General Bid Bulletin No. 26
31 May 2021

IFB NO. 20-031-6

SOUTH COMMUTER RAILWAY PROJECT
FOR PACKAGES CP S-04, CP S-05, CP S-06 AND CP S-07
CONSTRUCTION OF CIVIL STRUCTURES: VIADUCTS, BRIDGES,
NINE (9) STATIONS AND DEPOT

CP S04-07 Responses to Clarification Requests (Batch 17)

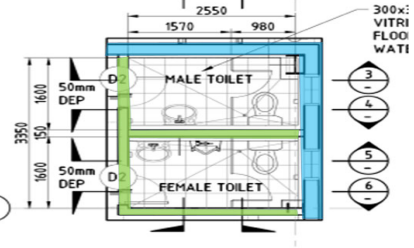
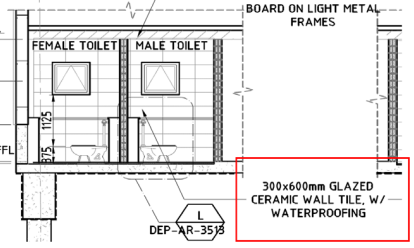
S-05		TS418		Soil Cement column	Please refer to TS418 Jet Grouting(soil cement column Foundation) in Bid Bullentin No. 20	We can't find 'TS418' in the PKG 5	<i>Bidder is referred to Addendum 3</i>
S-05						It has been informed that Rebar Supplier has protested, because of Rebar import from other countries, and finally Rebar could not be imported. Please advise if we can bring Rebar from overseas supplier(s).	<i>Bidders are responsible for developing their own supply chain strategies in relation to imported materials.</i>
S-05				BOQ 201(5)b	Pile cap excavation (in dry condntions) (unsuitable Material)	There are two different items in Pilecap excavation item No 201 (2)a : Pile cap Excavation in dry condition, No 201(5)b : Pile cap Excavation (in dry conditions) (Unsuitable Material). Please clarify how can we get the quantity for unsuitable material. What we understand is that unsuitable material quantity is calculated based on boring log and it shall be disposed. However, quantities from 201(2)a can be used for backfilling work.	<i>Please refer to the Technical Specifications, TS 200 and to the whole of Section TS 201.</i>

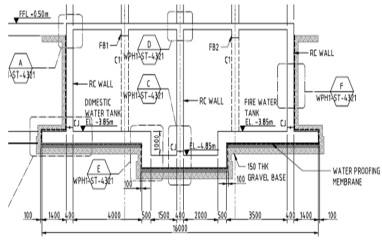
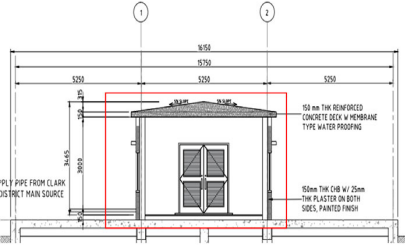
S-06		FIDIC General Conditions	19.1		In this Clause, “Force Majeure” means an exceptional event or circumstance: (a) which is beyond a Party’s control, (b) which such Party could not reasonably have provided against before entering into the Contract, (c) which, having arisen, such Party could not reasonably have avoided or overcome, and (d) which is not substantially attributable to the other Party.	<p>With respect to the COVID-19 pandemic (including potential future waves and/or mutations of the original virus), if the Contractor suffers delay and/or incurs Cost as a result of this delay, to the extent that such delay is:</p> <p>i) caused by undertaking additional HSE measures and directives/orders instructed by any legally constituted public authority (which were not existed at the Base Date); and/or</p> <p>ii) from the Contractor’s supply chain,</p> <p>the Contractor shall give notice to the Engineer and shall be entitled subject to Sub-Clause 20.1 [Contractor’s Claims] to:</p> <p>(a) an extension of time for any such delay, if completion is or will be delayed, and</p> <p>(b) payment of any such Cost plus profit, which shall be included in the Contract Price.</p>	<i>Bidders are requested to comply with all existing bidding document requirements in relation to Covid-19</i>

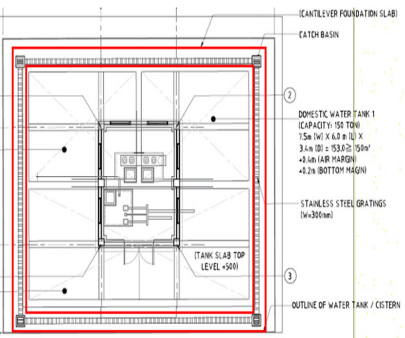
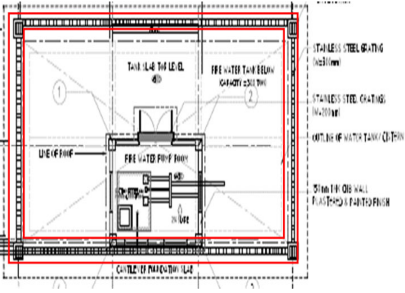
S-07		GBB 14	Page 68 of 76	Excavation TS 102.2.9 and at Annex A Measurement and Payment - 102.1.1 TS 201 Structural Excavation and Backfill	Please refer to TS Annex PINS issued in Addendum 2 102(1)a Unsuitable Excavation at dry condition	Hauling unsuitable material is different from Hauling ordinary surplus material. 1) Please provide the depth of unsuitable soil, to be used as basis of quantity for Hauling the unsuitable materials. 2) Please provide pay item for removal of unsuitable or surplus materials	<i>The Bidder is advised that Item 102(1)a is not applicable to CP S-07.</i>

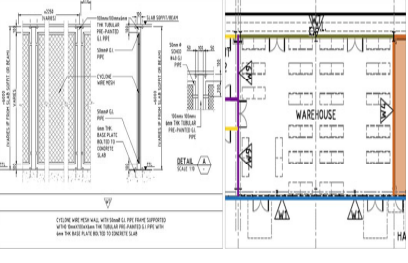
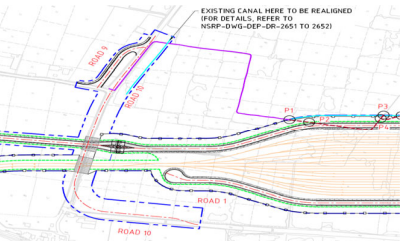
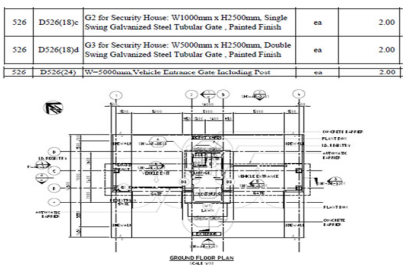
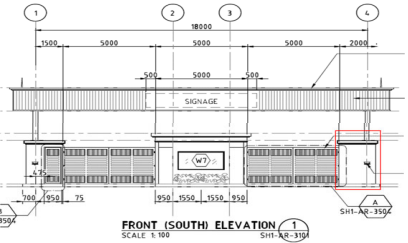
Package	Vol	Sec	Page No.	Clause No./Title	Reference Text (if necessary)	Clarification Request	Final Response
S-07		Volume 2, 02 Book 2 (Architectural), 01 S07 Arch	4 of 6	NSRP-DWG-WPH1-AR-3201 NSRP-DWG-WPH1-ST-4321 Pump House for Fire Water Tank 1		Please verify conflict in Slab Thickness for Elevated Slab shown between Architectural Plan and Structural Plan. Which shall govern	Structural will govern. Refer to NSRP-DWG-WPH1-ST-4321 Rev. 21.
S-07		Volume 2, 02 Book 2 (Architectural), 01 S07 Arch	4 of 6	NSRP-DWG-WPH2-AR-3201 NSRP-DWG-WPH2-ST-4311 Fire Water Tank 2		Please verify conflict in Slab Thickness for Elevated Slab shown between Architectural Plan and Structural Plan. Which shall govern	Structural will govern. Refer to NSRP-DWG-WPH2-ST-4311 Rev. 21.1
S-07		Bid Bulletin 16, Volume 1A Sec.4A BOQ_Add.2_20210 310		Bill of Quantities No. 4-2.13 Pump House for Fire Water Tank 1 Floor Finishes	BOQ D502(1) T=50mm, Plain Cement Troweled Finish with Hardener BOQ D505(1) Self-levelling Epoxy Paint Finish with Hardener	Please confirm our understanding of the following: 1. BOQ 502(1) 40 sq.m. is located at Roof Slab 2. BOQ 505(1) 34 sq.m. is located inside Pump Room	1)Item 502(1) has been deleted from the BOQ. Please refer to the Updated BOQ which shall be issued as Addendum 4. 2)Yes, Item 505(1) is located inside Pump Room.

S-07		Bid Bulletin 16, Volume 1A Sec.4A BOQ_Add.2_20210 310		Bill of Quantities No. 4-2.15 Pump House for Fire Water Tank 2 Floor Finishes	BOQ D502(1) T=50mm, Plain Cement Troweled Finish with Hardener BOQ D505(1) Self-levelling Epoxy Paint Finish with Hardener	Please confirm our understanding of the following: 1. BOQ 502(1) 50 sq.m. is located at Roof Slab 2. BOQ 505(1) 18 sq.m. is located inside Pump Room	1)Item 502(1) has been deleted from the BOQ. Please refer to the Updated BOQ which shall be issued as Addendum 4. 2)Yes, Item 505(1) is located inside Pump Room.
S-07		Bid Bulletin 16, Volume 1A Sec.4A BOQ_Add.2_20210 310		Bill of Quantities No. 4-2.12 Supply and Fire Water Tank 1 Floor Finishes	BOQ D502(1) T=50mm, Plain Cement Troweled Finish with Hardener - 369 sq.m.	Please verify location and quantity (369 sq.m.)	Item D502(1) shall be applied in the entire floor area of the Supply and Fire Water Tank 1. Please refer to the Updated BOQ which shall be issued as Addendum 4.

S-07		Bid Bulletin 16, Volume 1A Sec.4A BOQ_Add.2_20210 310		Bill of Quantities No. 4-2.14 Fire Water Tank 2 Floor Finishes	BOQ D502(1) T=50mm, Plain Cement Troweled Finish with Hardener - 110 sq.m.	Please verify location and quantity (110 sq.m.)	Item D502(1) shall be applied in the entire floor area of the Supply and Fire Water Tank 2. Please refer to the Updated BOQ which shall be issued as Addendum 4.

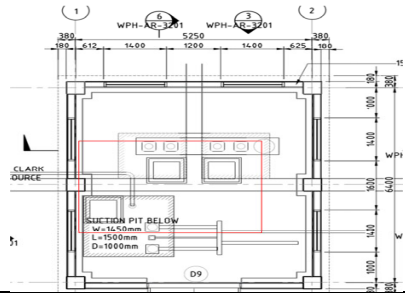
S-07		Vol. 02, Section 6 Appendix 15	Page 14	BIM Information Mgmt Flow		Please verify the direction indicated on Section 2 (see item 2 page 14) that BIM will focus on As-built Models	Contractor's to develop LOD 300 BIM Models provided by Employer/Engineer, to produce the LOD 500 As-built models and drawings.
S-07		Vol. 02, Section 6 Appendix 15	Page 25	BIM Information Mgmt Flow		Based on Item 4 Cluster/ Contract Packages, we will only have one (1) cluster. Please confirm for CPS07 will be under Cluster 001.	Confirmed CP S-07 is under Cluster 001.
S-07		Vol. 02, Section 6 Appendix 15		BIM Information Mgmt Flow	3. Under Section 7 COBie Standards	Please verify who will conduct actual onsite measurement for As-Built Model development, Is it by Contractor or by 3rd Party?	Contractor will conduct the actual onsite measurement and survey to be able to validate the developed As-built model.
S-07		Vol. 02, Section 6 Appendix 15		BIM Information Mgmt Flow	4. Under Section 7.7.2. COBie Information	1. Who would provide the COBie data sheet content. 2. Will this be given by the Client, if NO, will this be produce from the DCP4 by the BIM.	Upon receipt of the LOD 300 models from the Employer/Engineer, the Contractor shall develop and produce the COBie data sheet.
